Tuesday April 26, 2022
Medway Planning and Economic Development Board
155 Village Street
Medway, MA 02053
LIVE Meeting with Zoom availability

PLAN REVIEW ESTIMATE – Milford Regional Hospital Site Plan (86 Holliston Street):

EVERSOURCE SUBSTATION #65 SITE PLAN 12 & 34 WEST STREET FIELD CHANGES:

MEDWAY MILL – Field Change Requests:

APPROVED MEDWAY 65 SUBSTATION LAYOUT

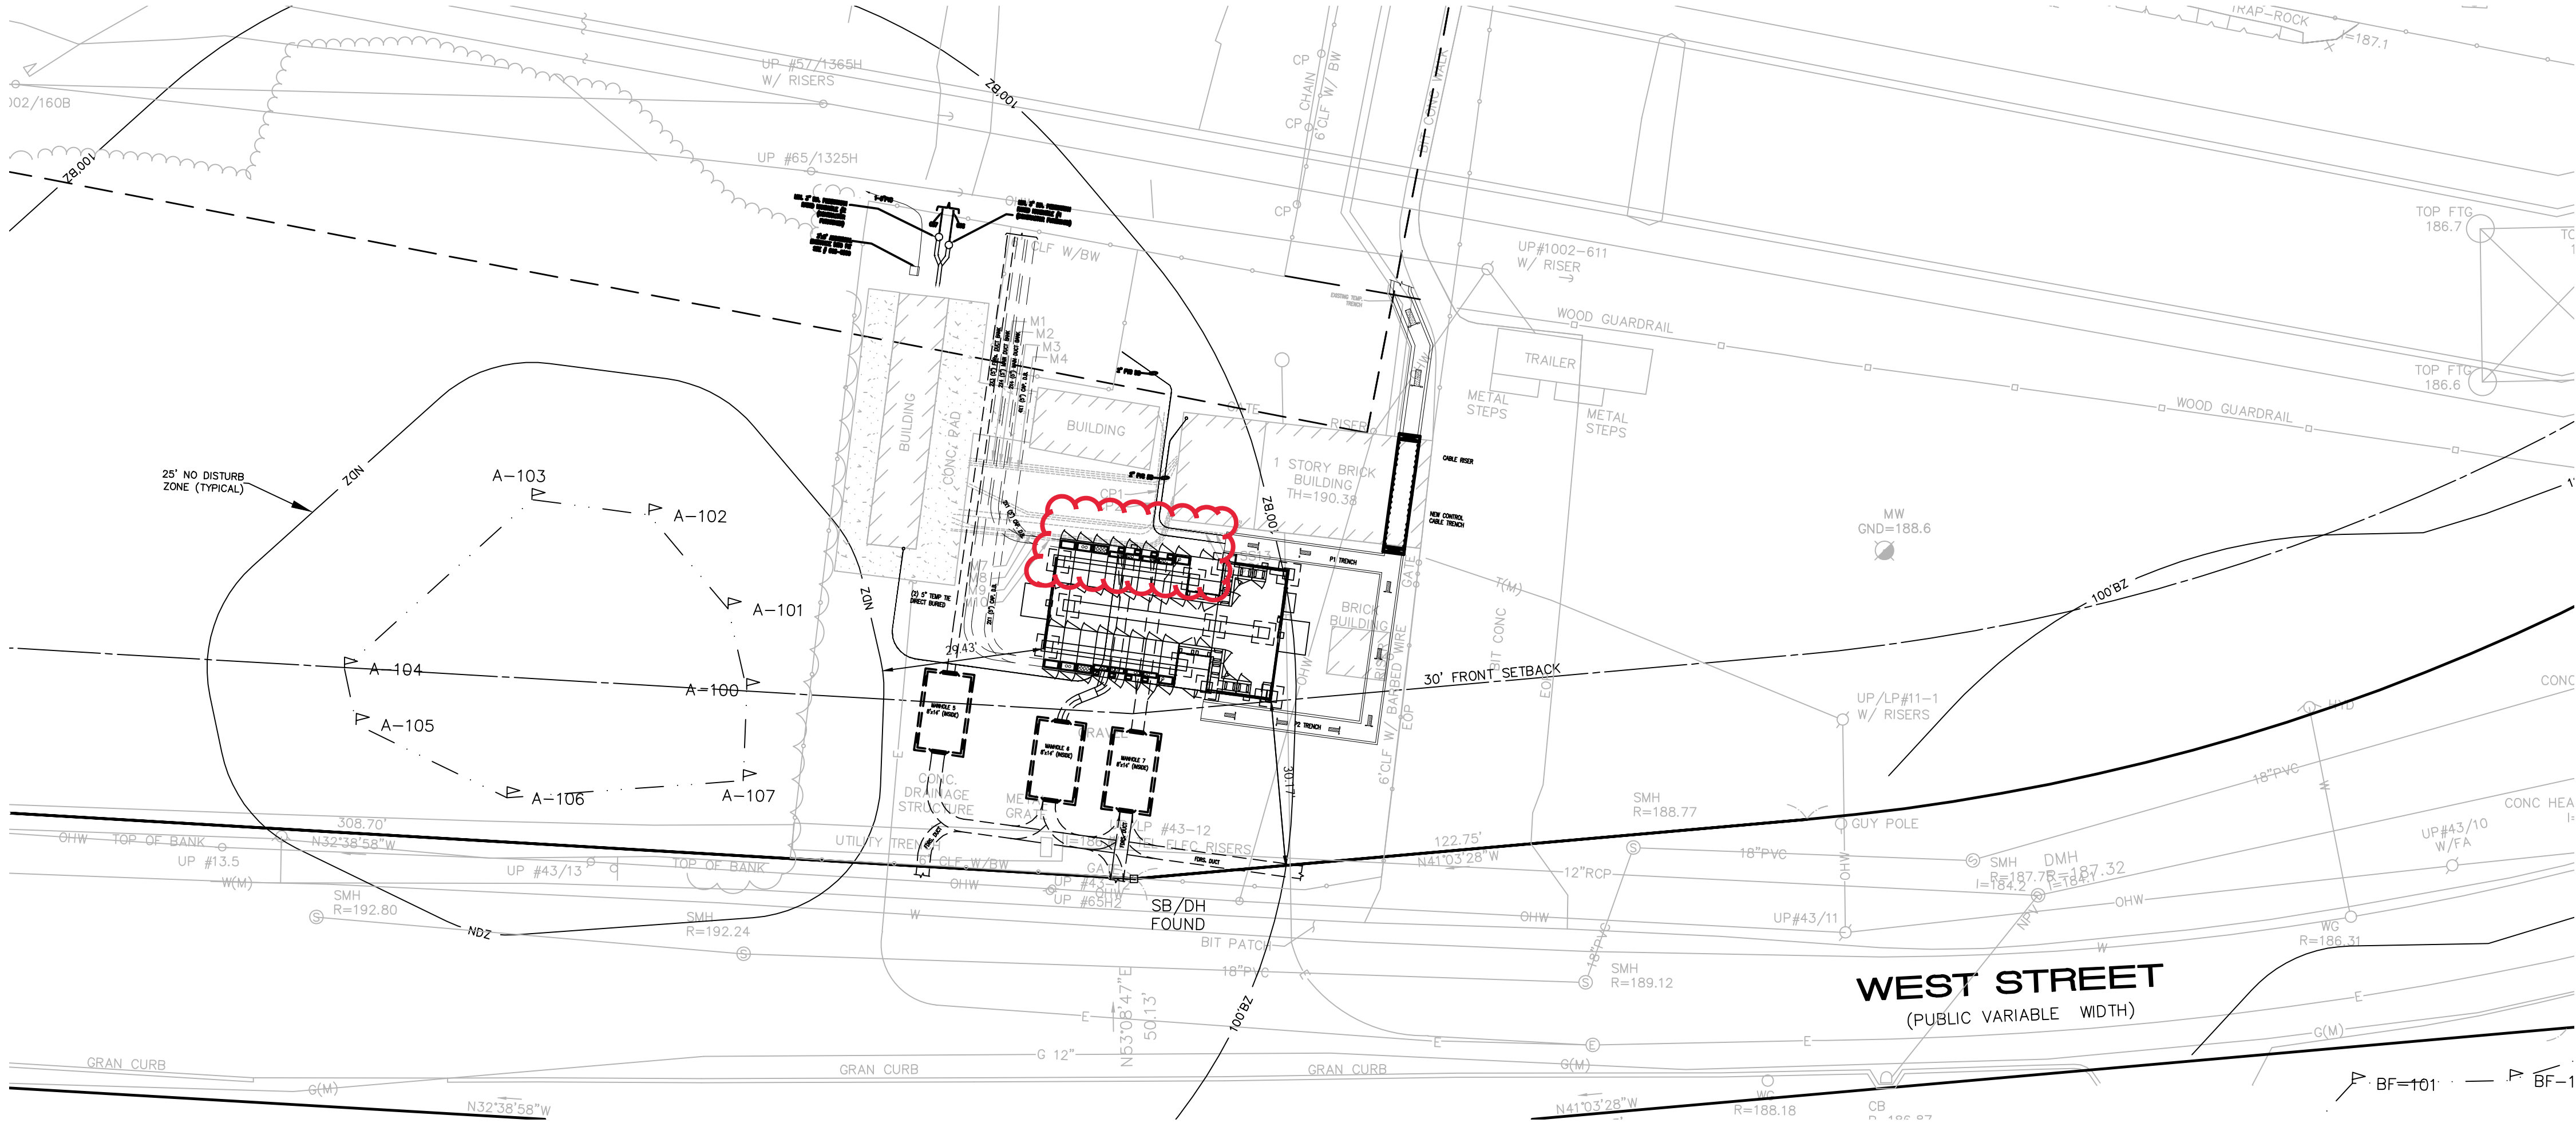
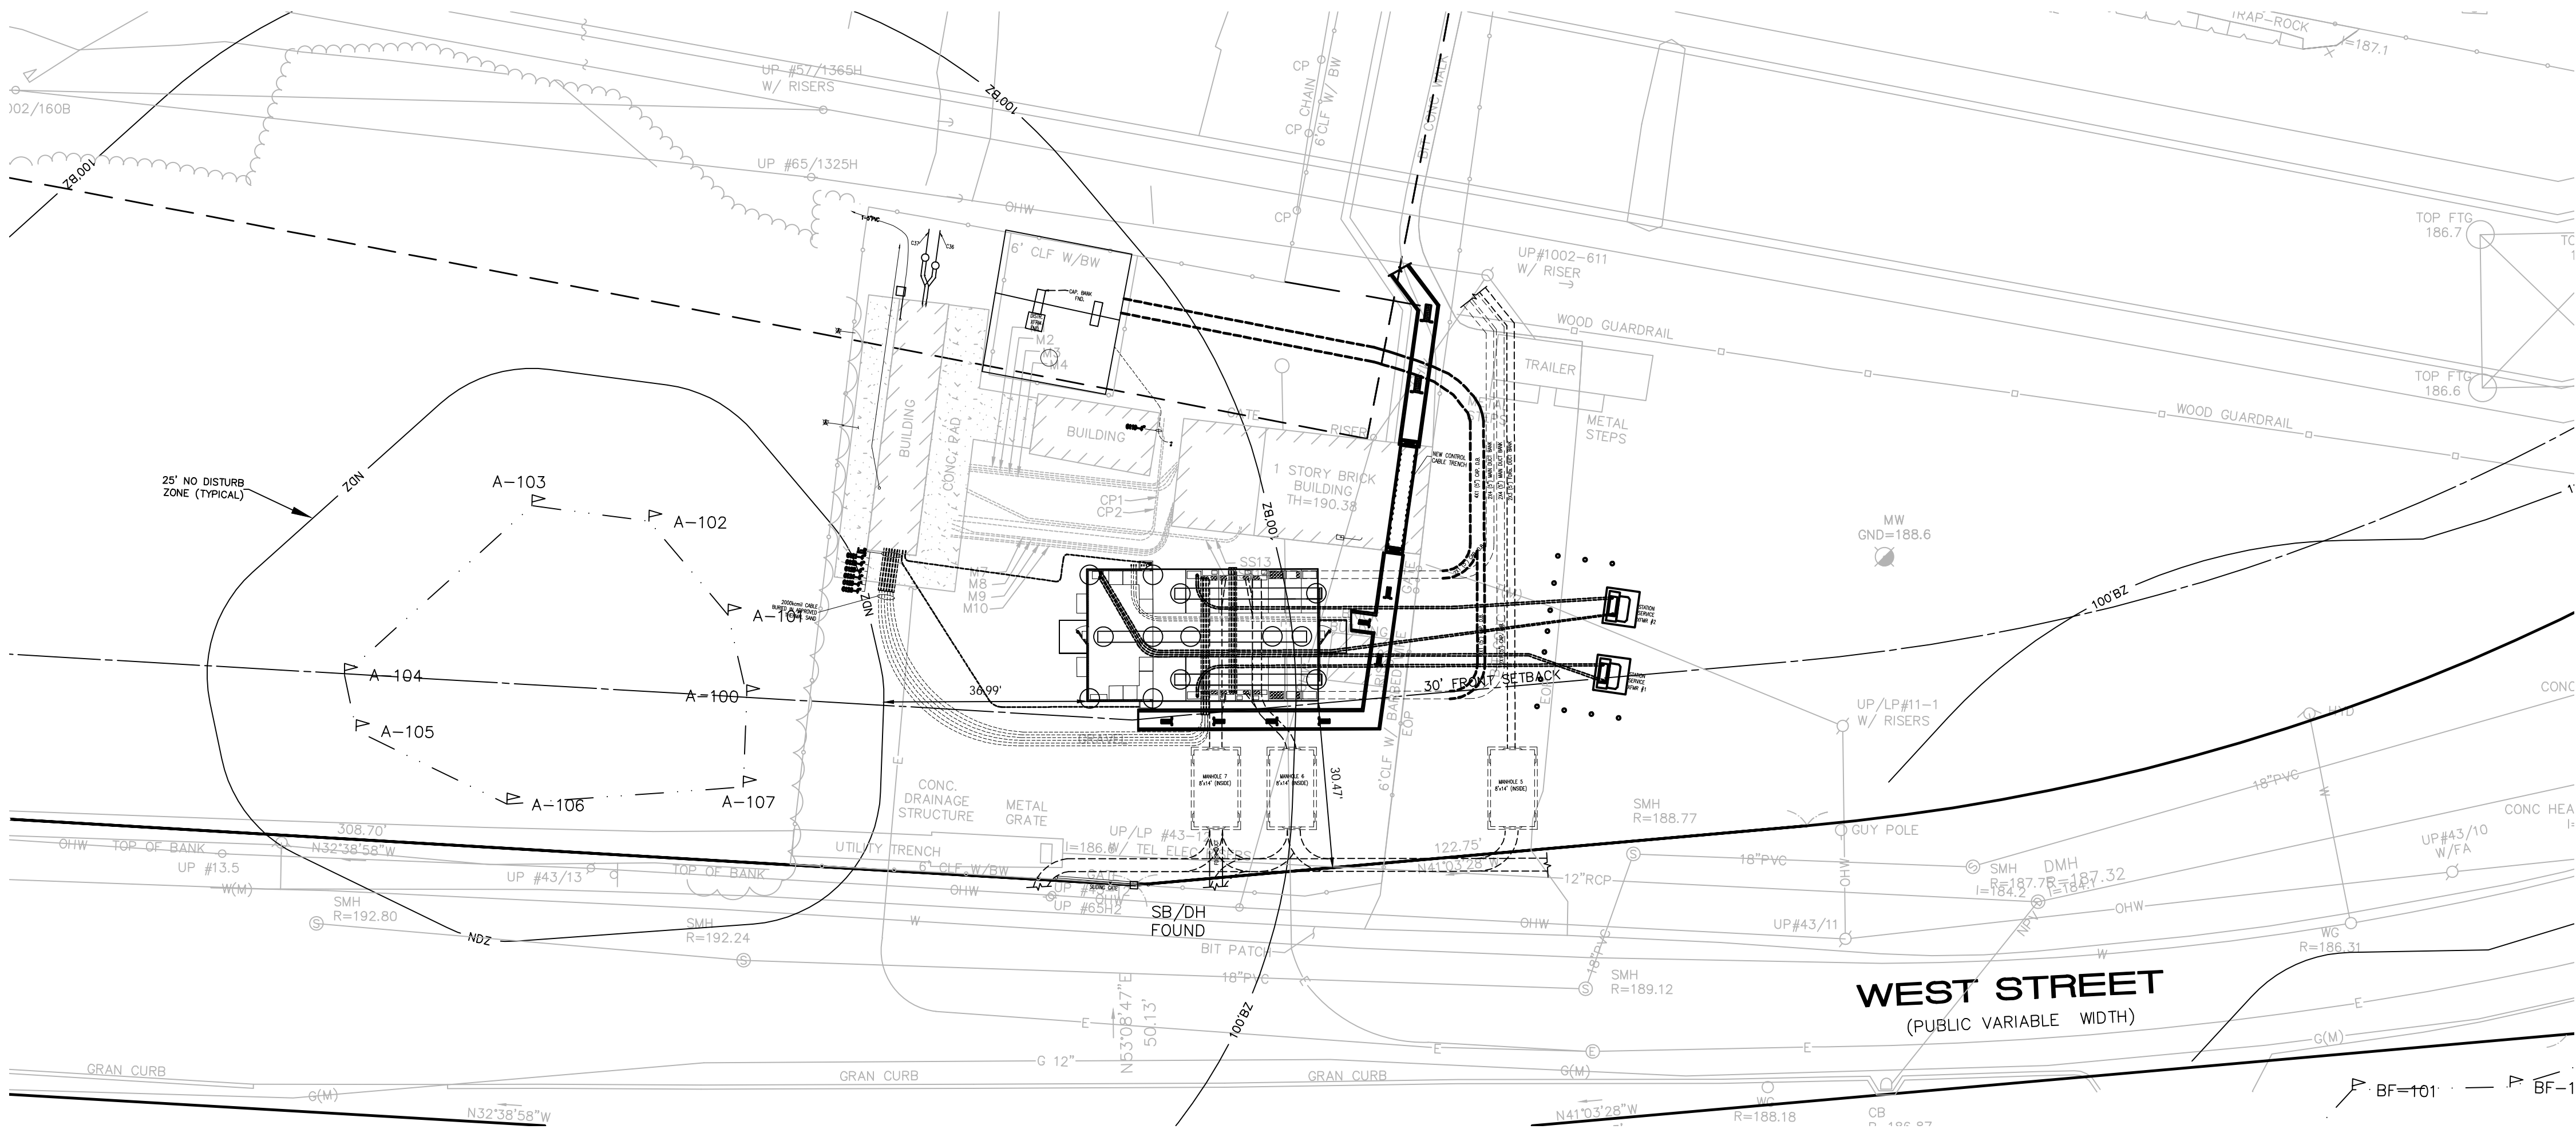
Attorney Joshua Lee Smith and Eversource Community Relations Coordinator were present via Zoom. It was explained that during construction, Eversource encountered some unanticipated underground conduits with active cables that obstruct Eversource's ability to install the new switchgear building based on its current design. The field change shows the design rotated for the new switchgear building 180 degrees and also shifting the proposed manholes and underground concrete duct banks farther away from the wetland area. The change is also for temporarily storing some material in the approved laydown area. The culvert will be replaced in kind. Consultant Bouley has no issues with the noted field change. The Board was informed that the Building Inspector has no issues with the field change.

On a motion made by Bob Tucker, seconded by Rich Di Iulio, the Board voted unanimously to approve the field change for Eversource.

DRAWING: C6.1
SHEET 7 OF 14

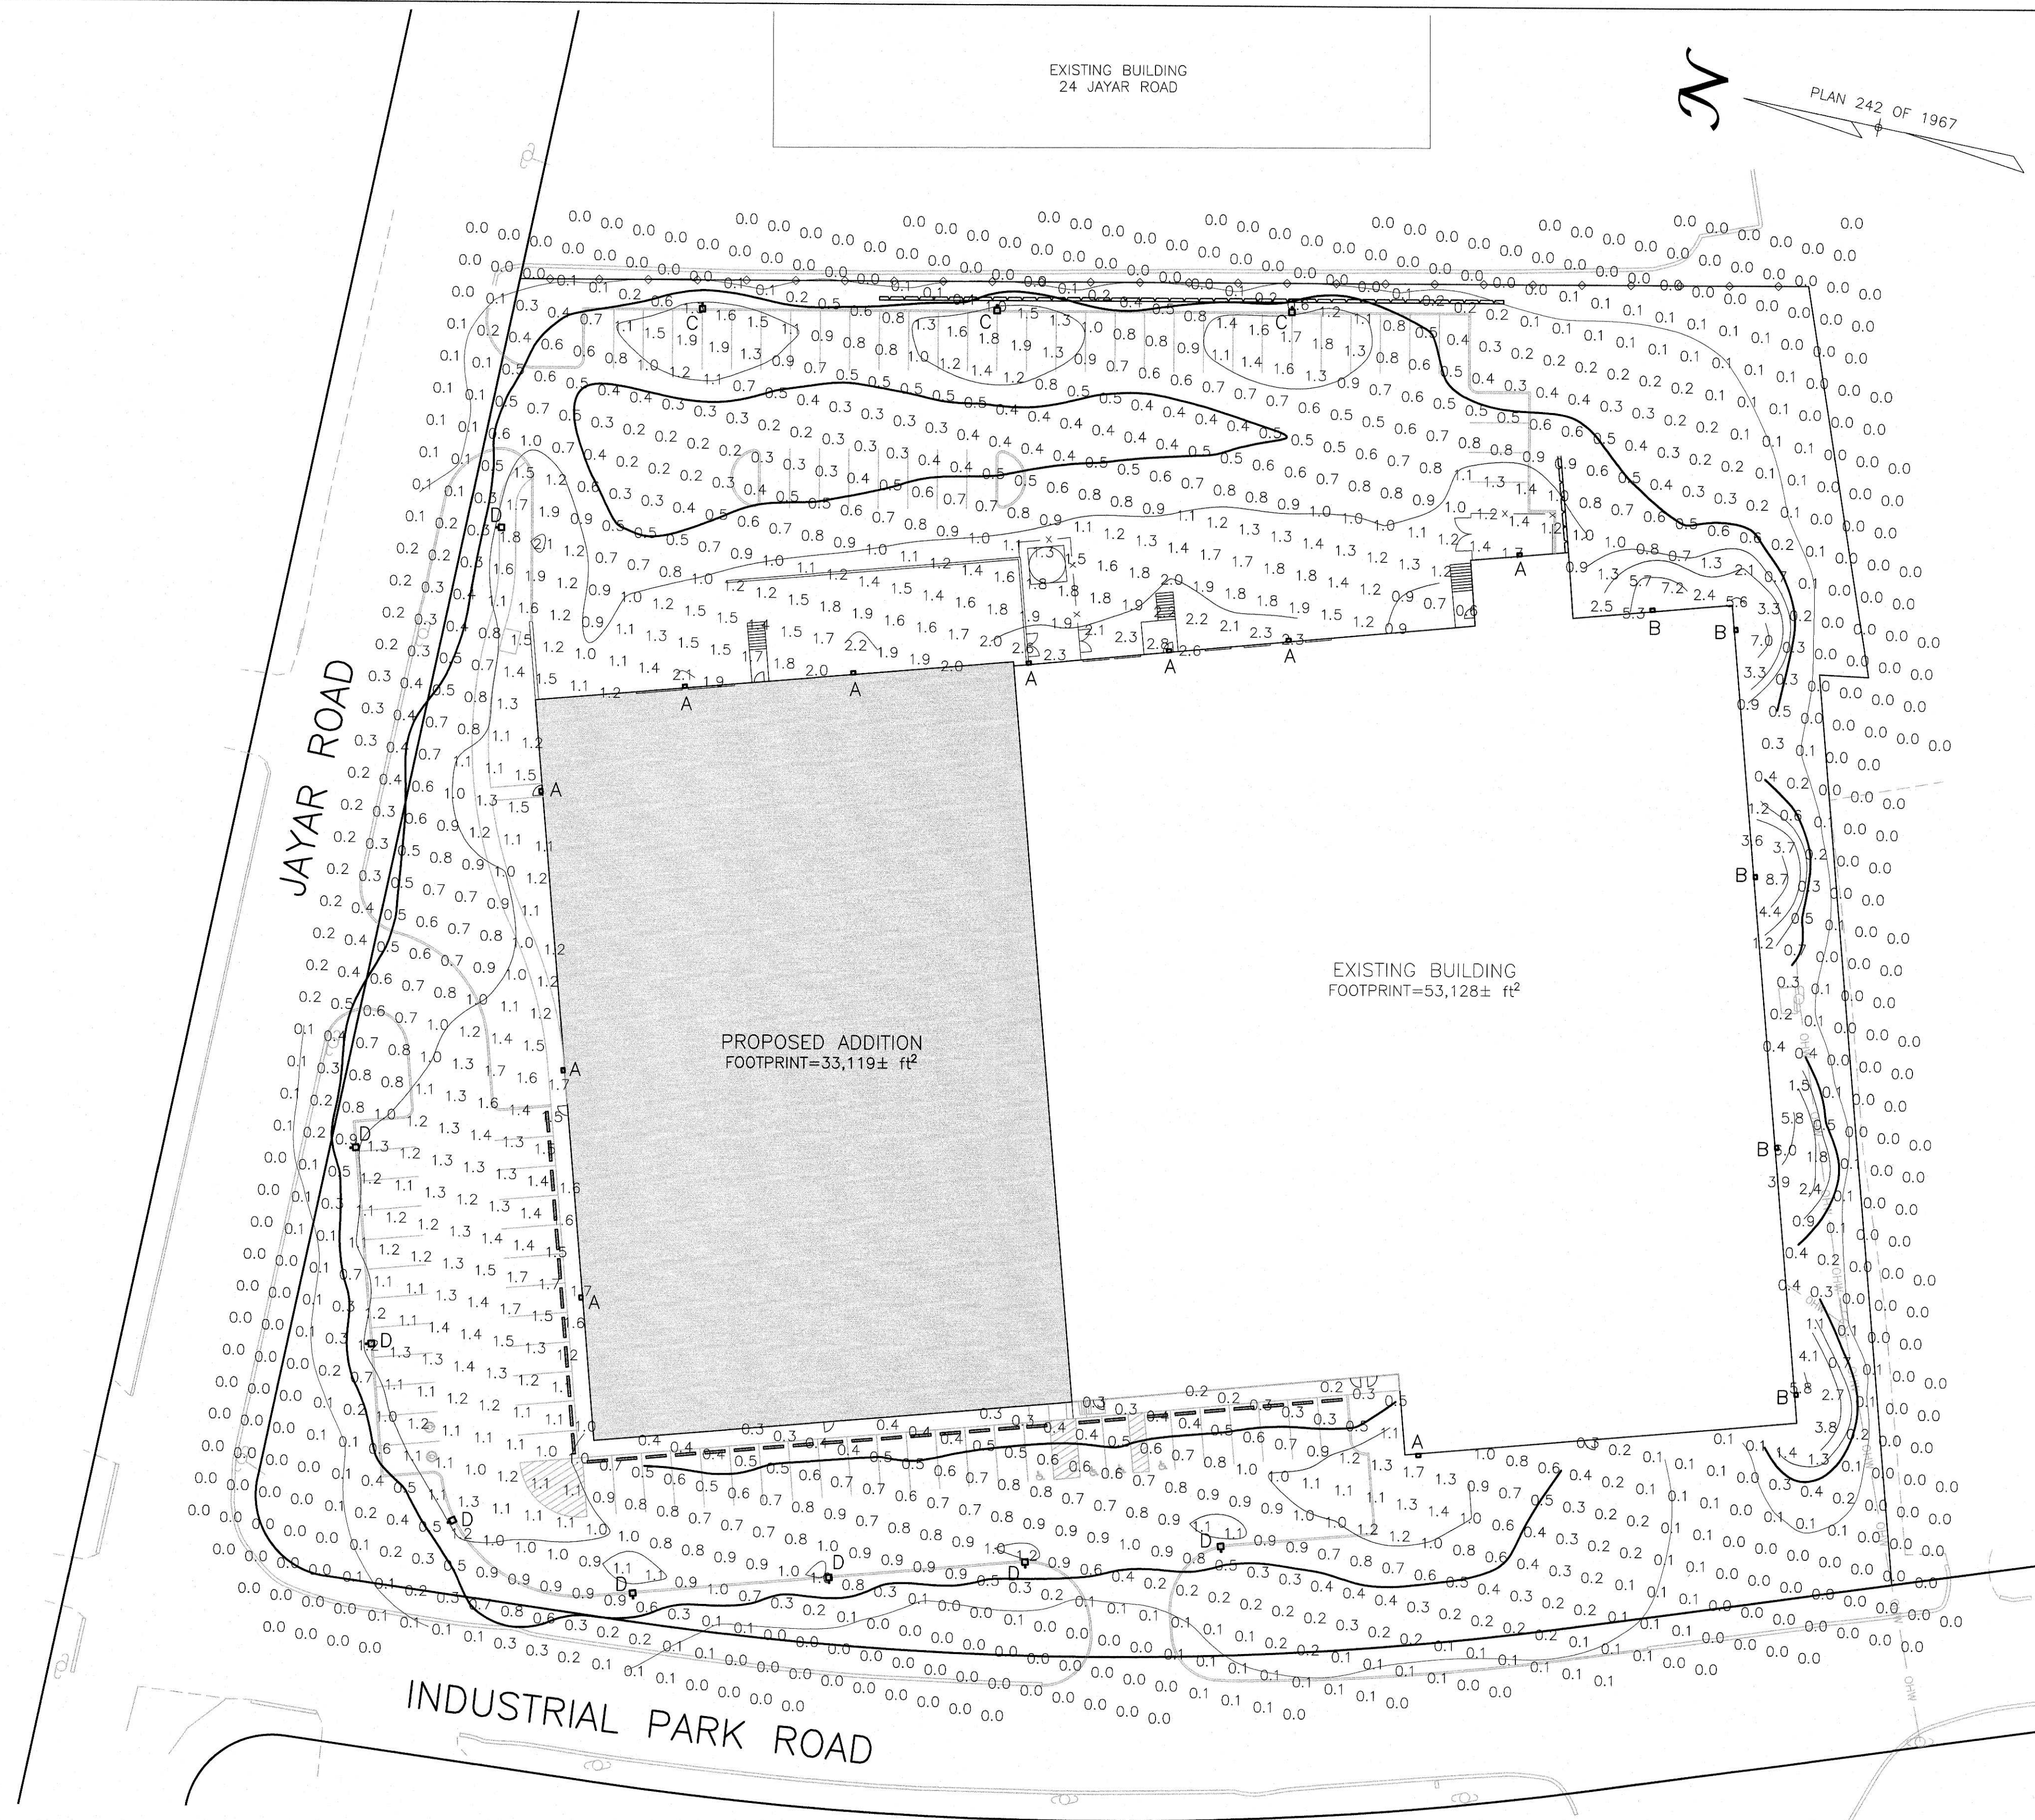
- The lighting plan was revised and reviewed by Tetra Tech they have no issues with the proposed changes and have reviewed the plan and no light trespass is proposed.
- There is a request to shorten the fence by the four feet will help with sight distance pulling out of the new parking area and should have no impact on screening of the project for the abutters.
- The applicant is also requesting a substitute 5” standing granite opposed to 6” standing granite curbs. The product for 5” is difficult to find. Tetra Tech has no issue with the change in curb.
